UNITED STATES
NUCLEAR REGULATORY COMMISSION
WASHINGTON, D.C. 20555

Subject: Board Notification BN-83-16

SUBJECT: NOTIFICATION OF VIOLATION AND PROPOSED
IMPOSITION OF CIVIL PENALTIES (BN-83-16)

FACILITY: Midland Plant, Units 1 & 2

SETTLEMENT MONITORING MATRIX

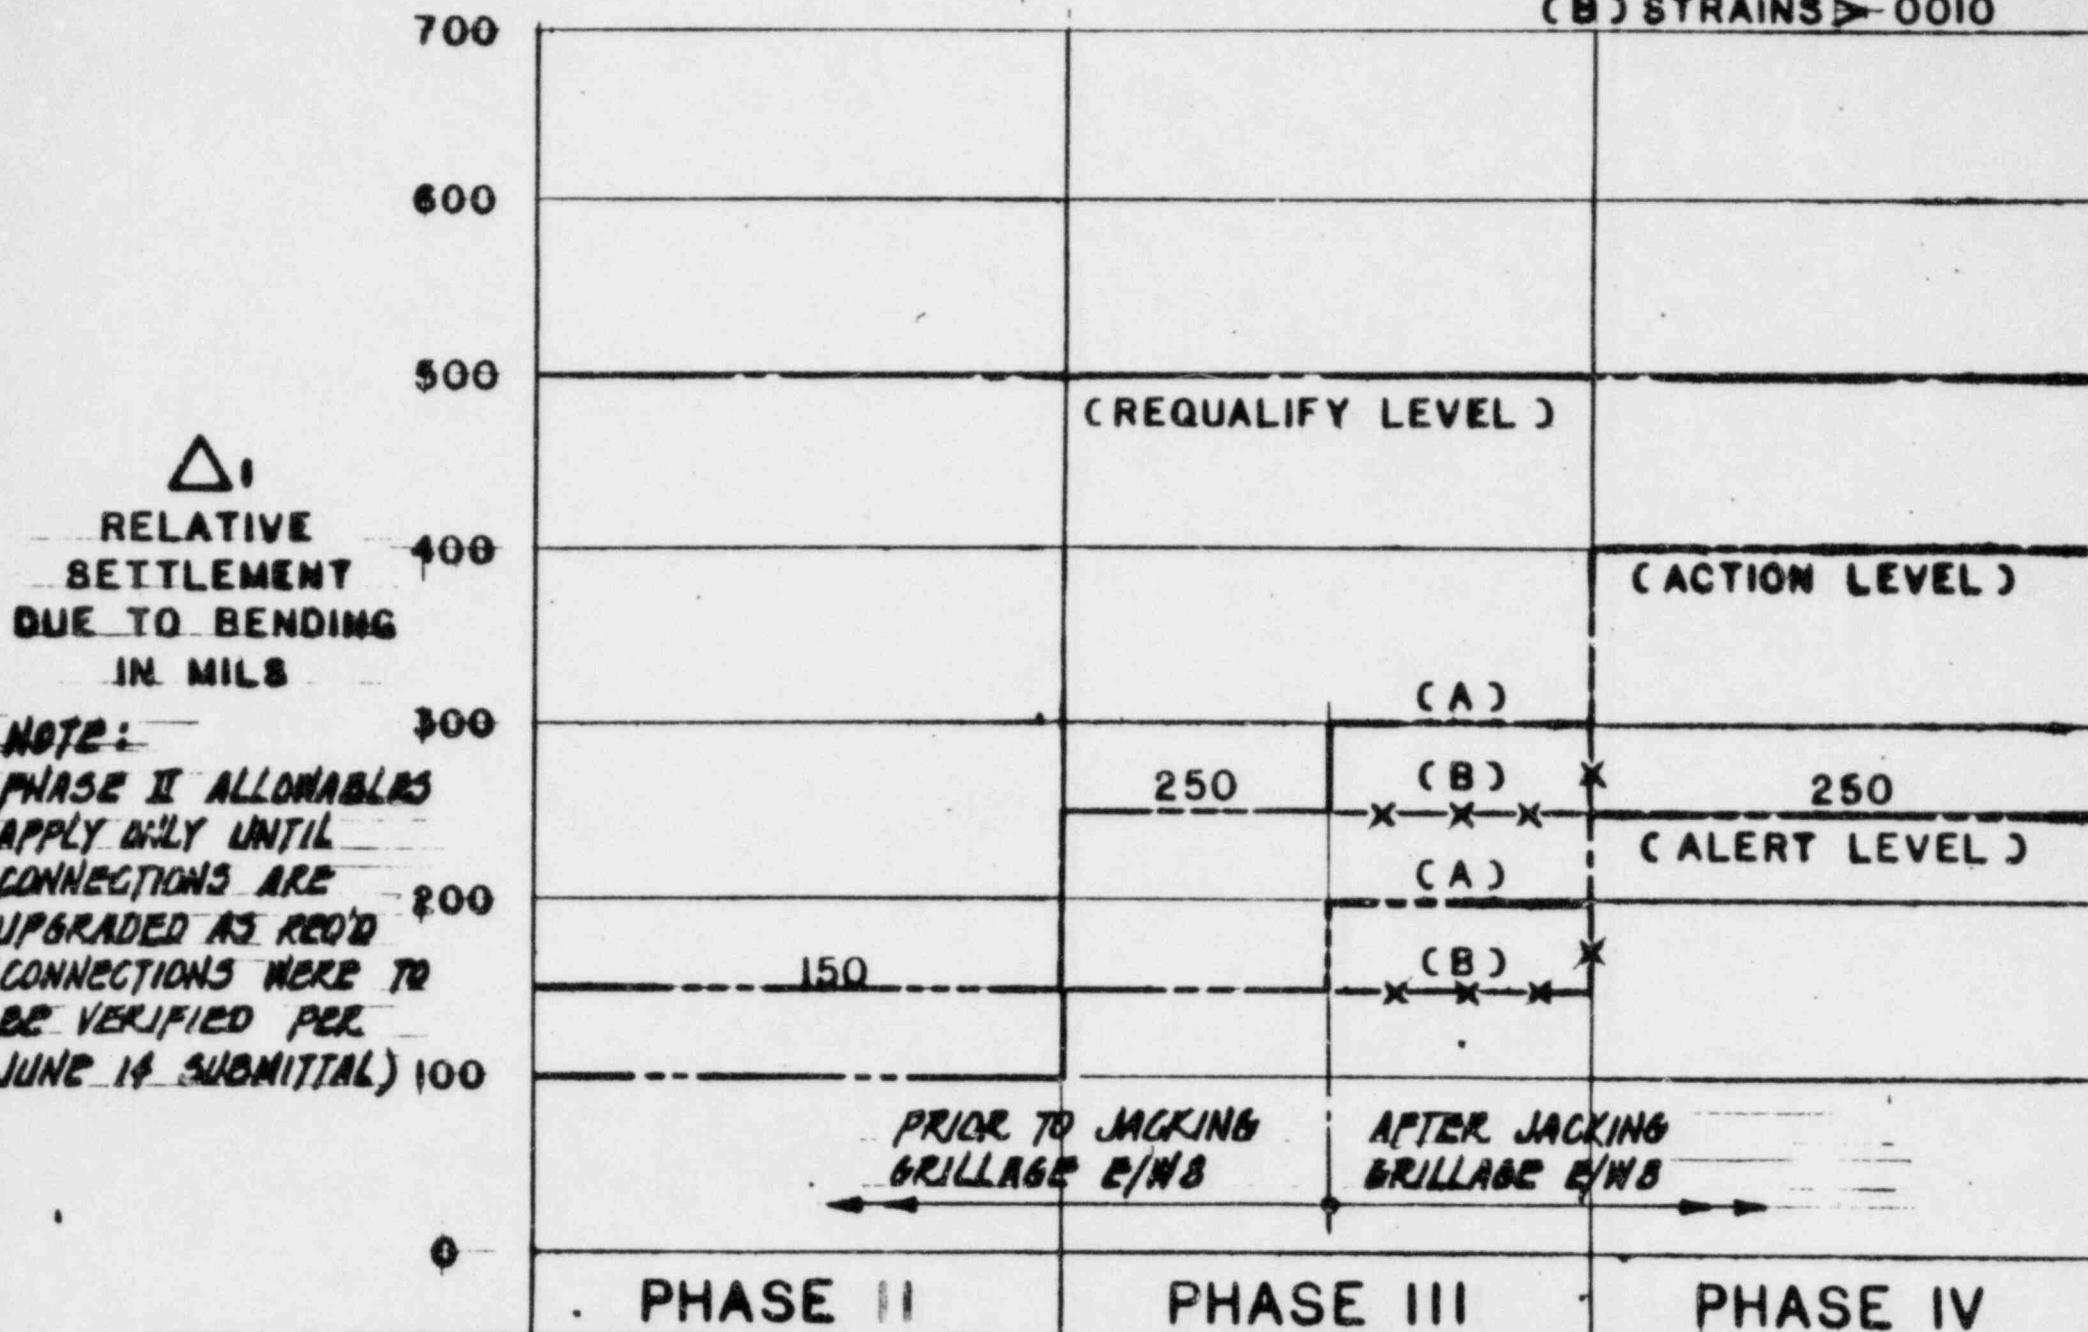
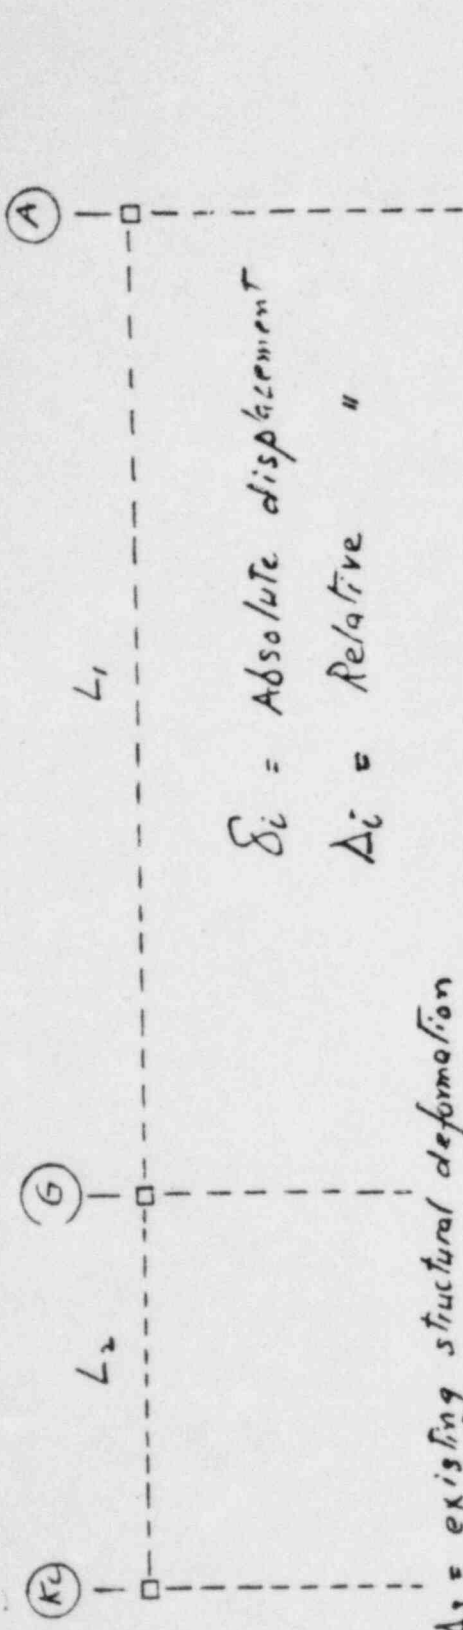
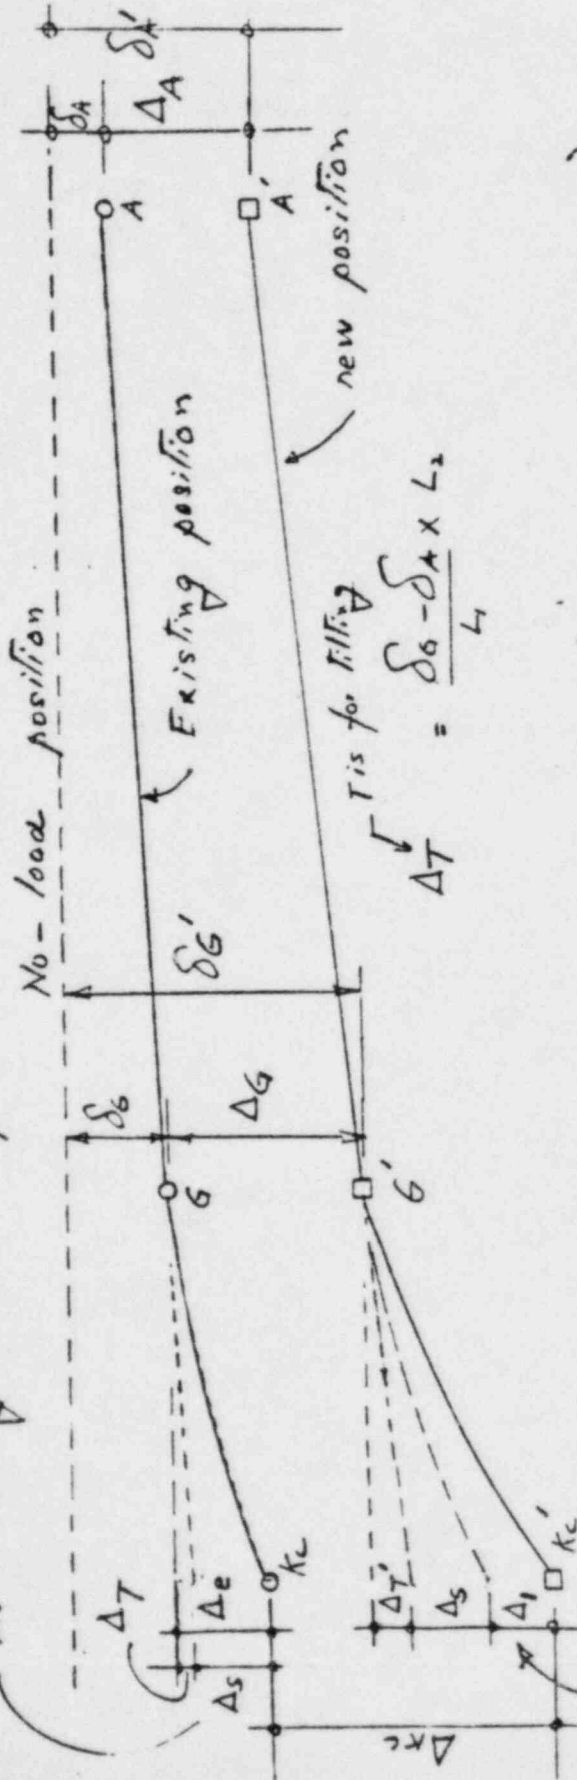
An updated copy of the monitoring matrix (Bechtel Drawing 7220 C-1493(Q), Rev. 1) (Attachment 7) was provided. Alert, action and requalify levels will be added as agreed above (AB Item 1).
